DEVELOPMENT NO.:	21031474
APPLICANT:	14 JOHNSTON PTY LTD
ADDRESS:	14 JOHNSTON ST STIRLING SA 5152
NATURE OF DEVELOPMENT:	Construction of a three-level childcare centre (pre-school) with ancillary car parking, outdoor play areas and landscaping
ZONING INFORMATION:	Zones: <ul style="list-style-type: none"> • Suburban Main Street Overlays: <ul style="list-style-type: none"> • Hazards (Bushfire - Medium Risk) • Mount Lofty Ranges Water Supply Catchment (Area 2) • Native Vegetation • Prescribed Water Resources Area • Regulated and Significant Tree • Traffic Generating Development Technical Numeric Variations (TNVs): <ul style="list-style-type: none"> • Maximum Building Height (Metres) - 10 Metres • Maximum Building Height (Levels) - 2 Levels
LODGEMENT DATE:	12 Oct 2021
RELEVANT AUTHORITY:	Assessment Panel at Adelaide Hills Council
PLANNING & DESIGN CODE VERSION:	Operative Version 2021.14 - (23 September to 13 October 2021)

This application was previously presented to the 9 March 2022 meeting of the Adelaide Hills Council Assessment Panel, with a detailed assessment report setting out the assessment matters for the Panel's determination and provided the Panel with all relevant plans and

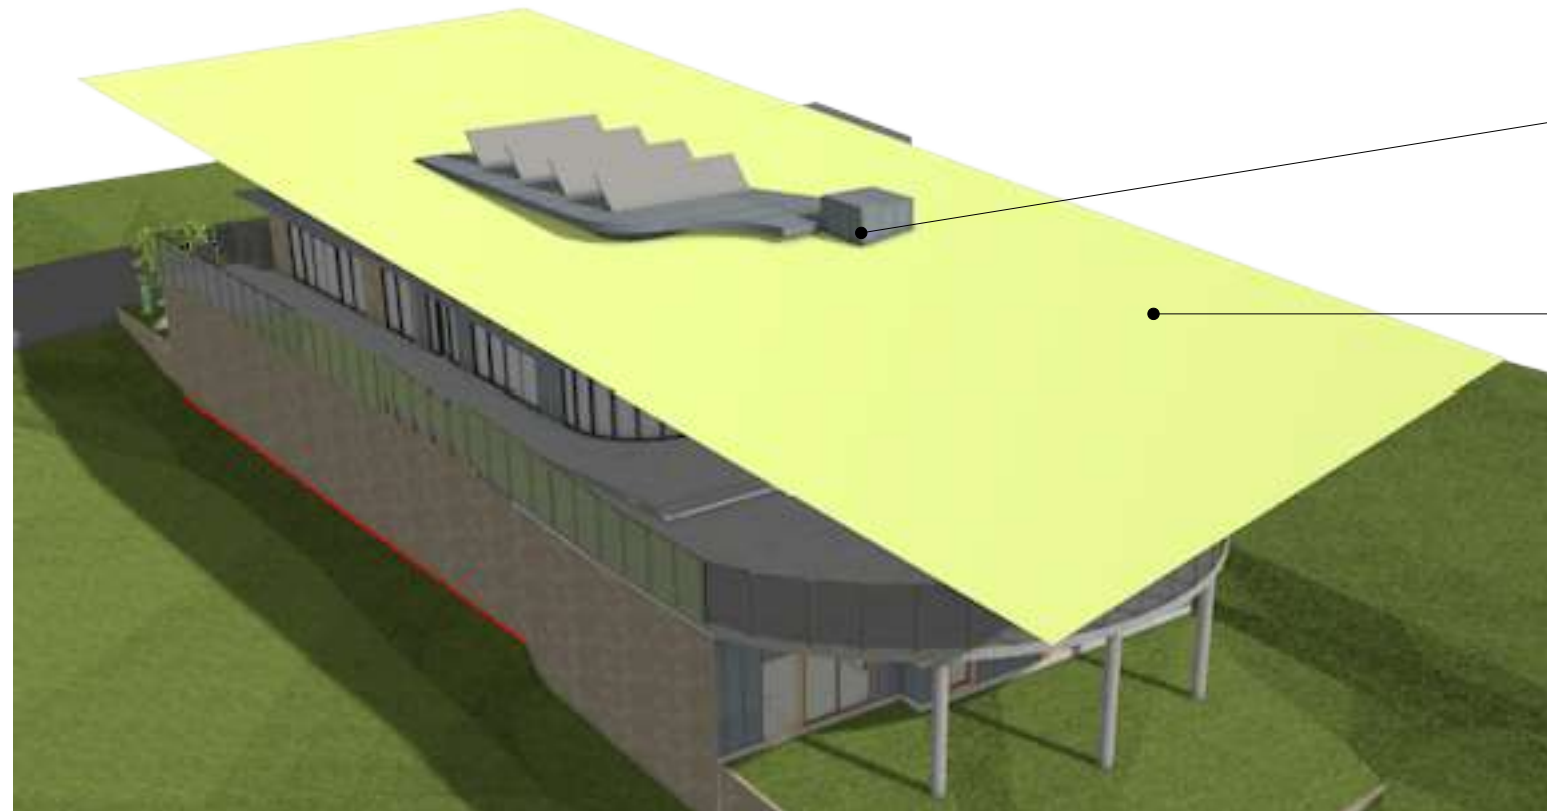
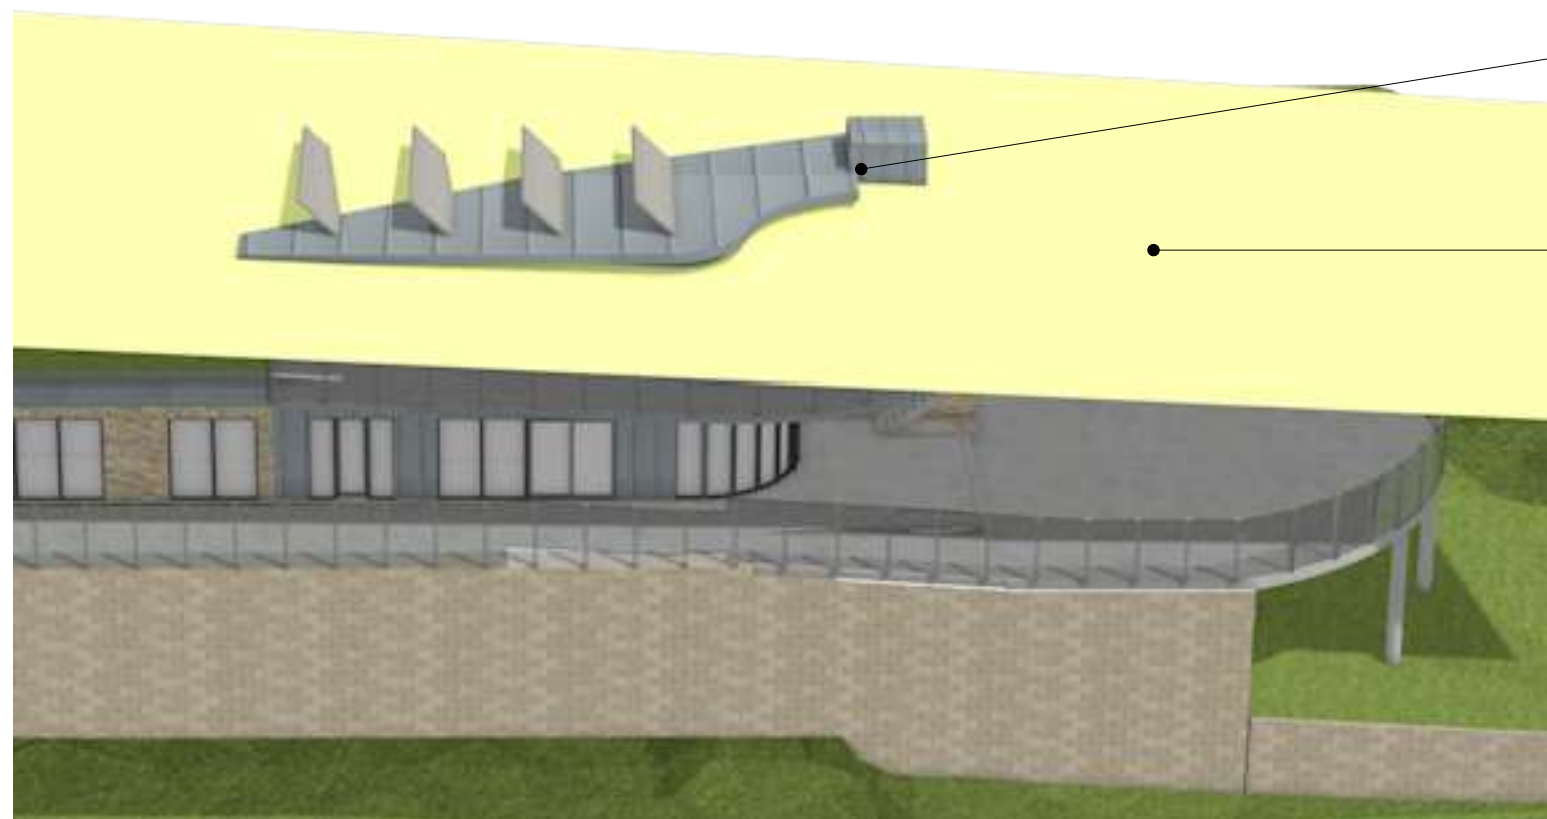
The proposal has also further varied its overall height and bulk in response particularly to the parking requirements and the car-stackers. The resultant building height further departs from the building height provisions for this locality in the Suburban Main Street Zone. Where previously a minor 400mm height departure was proposed, this has now increased the building to more than 1.2 metres over the prescribed building height limit. It is acknowledged that the site contour had already been considered in respect of concealing the three-storey design within a locality that supports buildings to a maximum of two-levels but the building height departure is now substantial at 1.2 metres.

SMALL ENCROACHMENT ABOVE 10m BUILDING HEIGHT BY LIFT OVERRUN, PV PANELS AND CORNER OF UPPER LEVEL ROOF (NOM. 800mm)

Figure 2 Play Area 1 Treatments

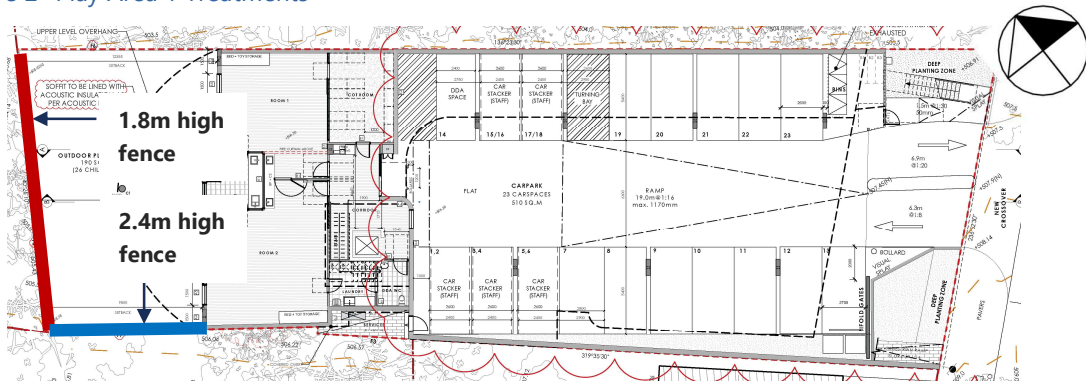
- Ensure the extent of the fences depicted in Figure 2 as blue is a minimum of 2.4m in height and red is a minimum of 1.8m in height when measured above the Outdoor Play Area 1 ground level

Figure 3 Play Area 2 and 3 Treatments

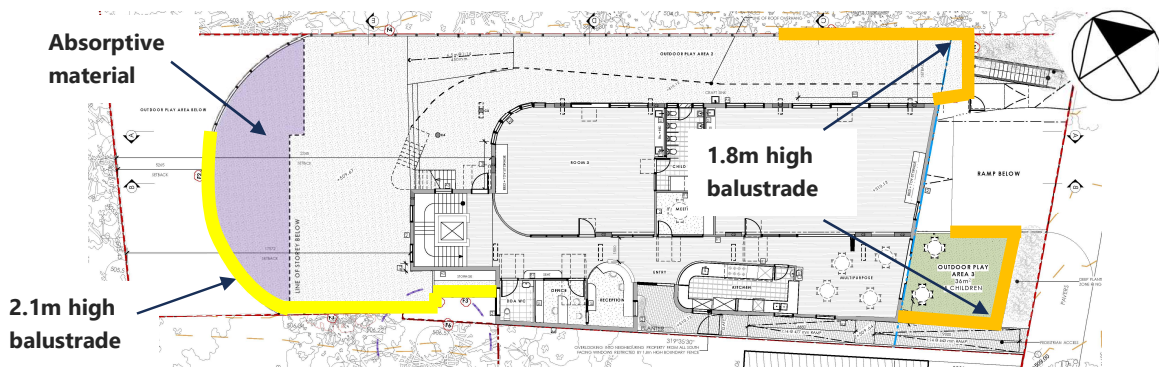
- Ensure the extent of the balustrade depicted as yellow in Figure 3 is a minimum of 2.1m in height when measured above the deck
- Ensure the extent of the balustrade depicted as orange in Figure 3 and Figure 4 is a minimum of 1.8m in height when measured above the deck

- Provide acoustic absorption to the soffit of the slab above the Play Area 1 for the extent shown as purple in Figure 3 and in accordance with Figure 5 below or by directly fixing material such as 25mm thick *Pyrotek "Reapor"* panels

Figure 6 Condensing Unit Treatments

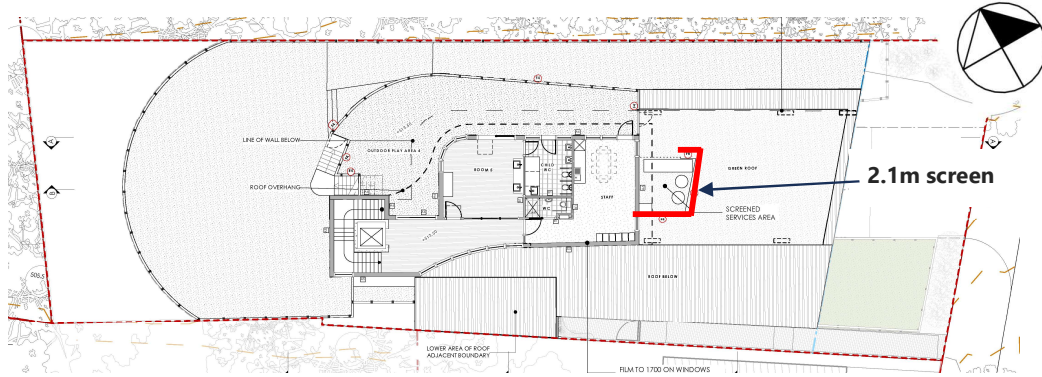
- Ensure the extent of screening depicted in Figure 6 as red is a minimum of 2.1m in height. Construct the screen from sheet steel with a base material thickness (BMT) of 0.42mm, or an alternative material with the same or greater surface density. No matter the material used, the screen should be sealed airtight at all junctions, including with the building and at the overlap of sheets. Small gaps may be left for drainage at the junction with the roof

Figure 8 Car Stacker Support – Section Detail

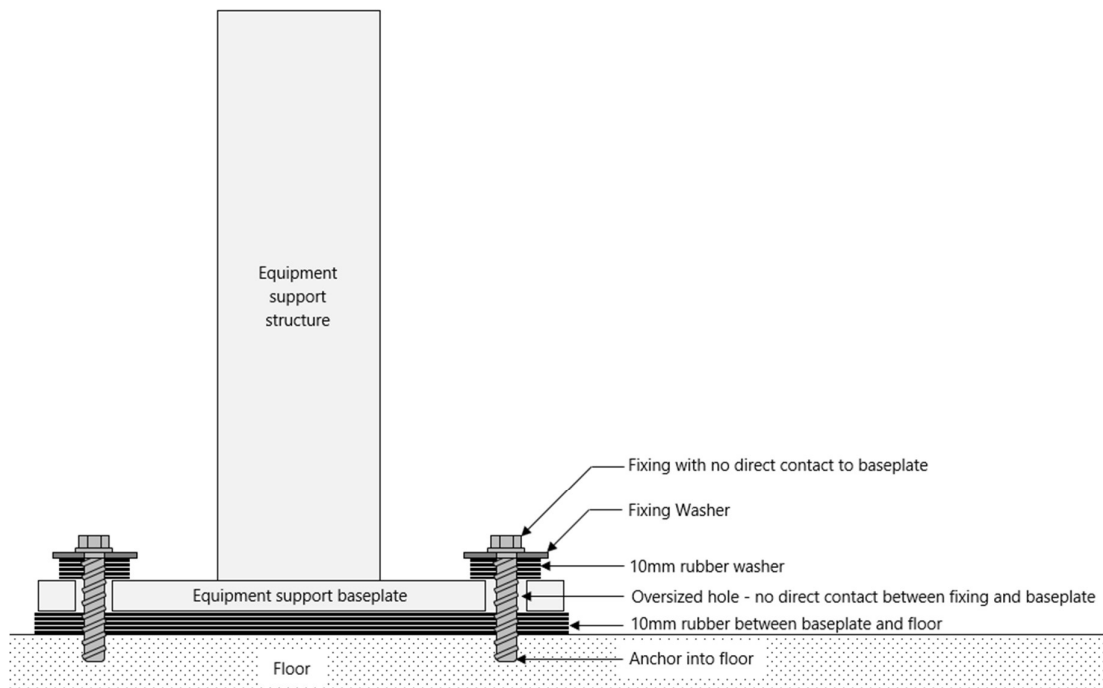
- Incorporate an additional 20 dB(A) of attenuation in the mechanical services ductwork between the kitchen exhaust fan and the external discharge
- Mount the car stackers on the northern side of the basement car park in accordance with Figure 8

Figure 4-2: Bin storage and collection detail. Red/GW = General Waste, Blue/CBD = Cardboard, Yellow = Mixed Recycling, Green = Food Waste.

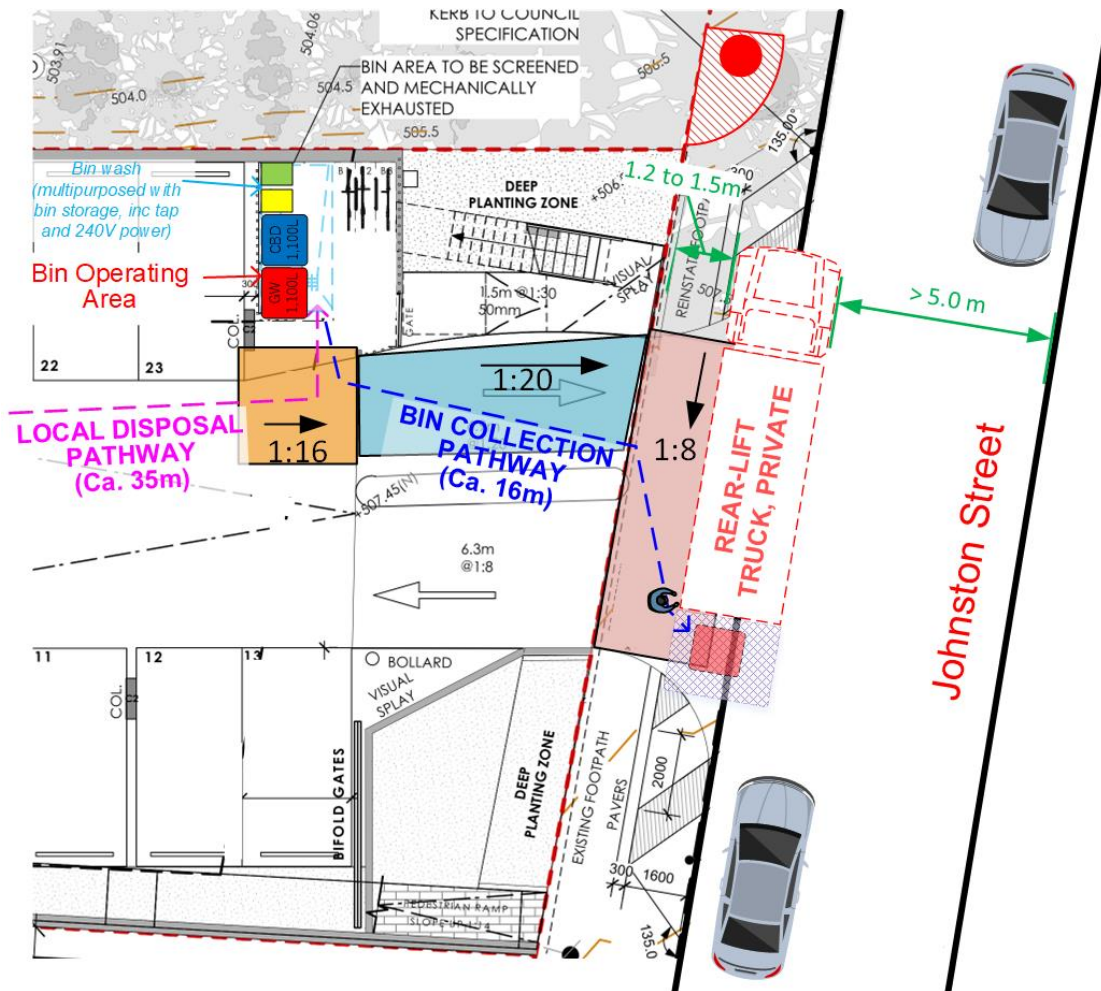
4. Waste collection vehicle (Private Contractor) would be a Rear-Lift Truck and would stop on Johnston Street as shown in Figure 4-2. This position would block the car park entry and exit.

It is proposed that the kerb along the front of the site on Johnston Street be reconstructed as a rollover kerb. As shown in Figure 4-2, this would allow the waste truck to encroach into this area and consequently provide a trafficable road width of approximately 5 m between the edge of the truck and the opposite side of Johnston Street during periods when waste is being collected in front of the site. Outside of these periods it is anticipated that the existing No Stopping restriction would continue to apply along this section of roadway. This would improve visibility of oncoming traffic for cars travelling down Johnston Street.
